# NORTHEAST ELEMENTARY SCHOOL ADDITION

RE: SUB 2002-71 -- One-Step Final Plat of Northeast Elementary School Addition

RE: SUB 2002-71 -- One-Step Final Plat Northeast Elementary School Addition

**CASE NUMBER:** SUB 2002-71 -- NORTHEAST ELEMENTARY SCHOOL ADDITION

FINAL PLAT

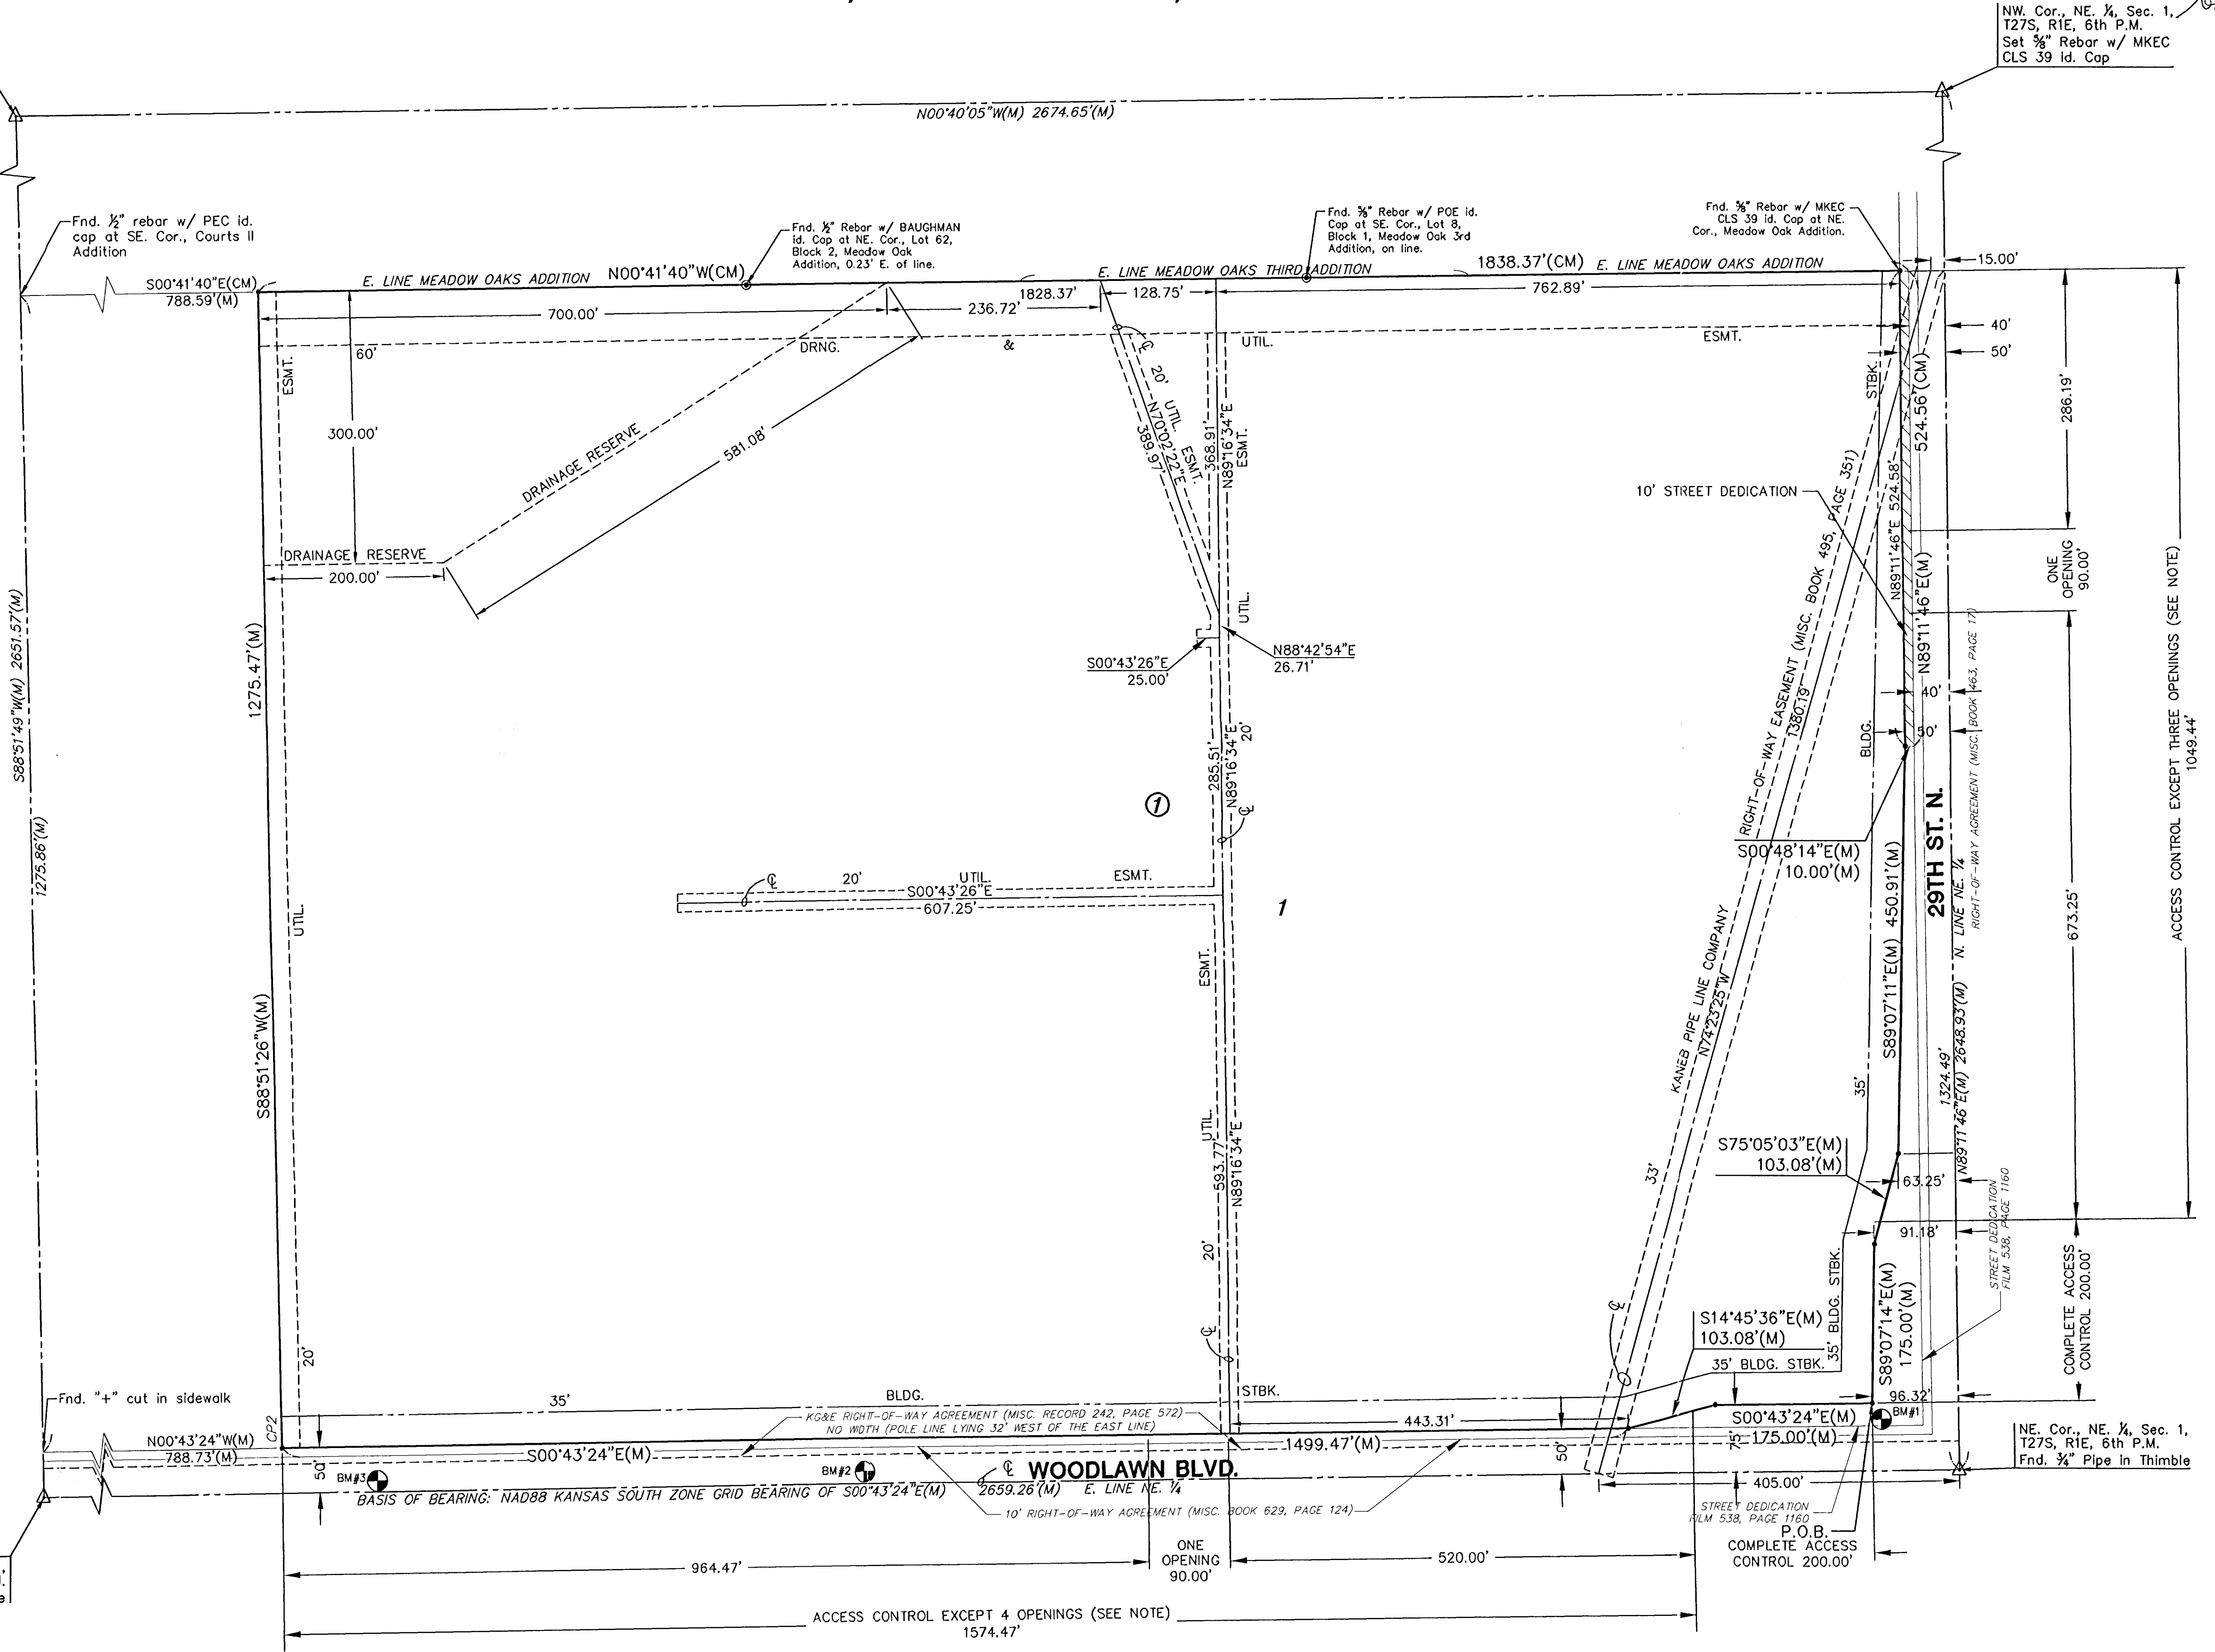
- C. The platting of minimum building elevations should be noted on the face of the plat and referenced in the plat's text.
- D. City Engineering needs to comment on the status of the applicant's drainage plan. A drainage reserve is needed in the southwest corner of the site. An off-site drainage easement is also needed.

- E. Traffic Engineering needs to comment on the access controls. The plat proposes four access openings along Woodlawn and three openings along 29th St. North. Distances should be shown for all segments of access control. The first opening with full turning movements along Woodlawn shall align with Pepperwood Road across Woodlawn. Spacing shall be 400 feet between the two subsequent openings; however the southernmost opening shall be at least 400 feet from the existing opening on the adjacent property to the south. Two openings are permitted along 29th St. North. The first opening with full turning movements along 29th St. North shall be at least 400 feet from the intersection; the second opening shall align with the existing opening across 29th St.

- F. Traffic Engineering needs to comment on the need for improvements to perimeter streets. Traffic Engineering has required a petition for left turns at the entrances from Woodlawn. Signalization may be required upon further review by the Traffic Engineer.

- G. The applicant shall submit a copy of the instrument which establishes the pipeline easements on the property, which verifies that the easements shown are sufficient and that utilities may be located adjacent to and within the easements. Any relocation, lowering or encasement of the pipeline, required by this development, will not be at the expense of the City.

- H. The applicant's agent shall determine any setback requirements for the pipelines by researching the text of the pipeline agreements. If a setback from the pipeline easements is provided for in the pipeline easement agreements, it shall be indicated on the face of the plat.
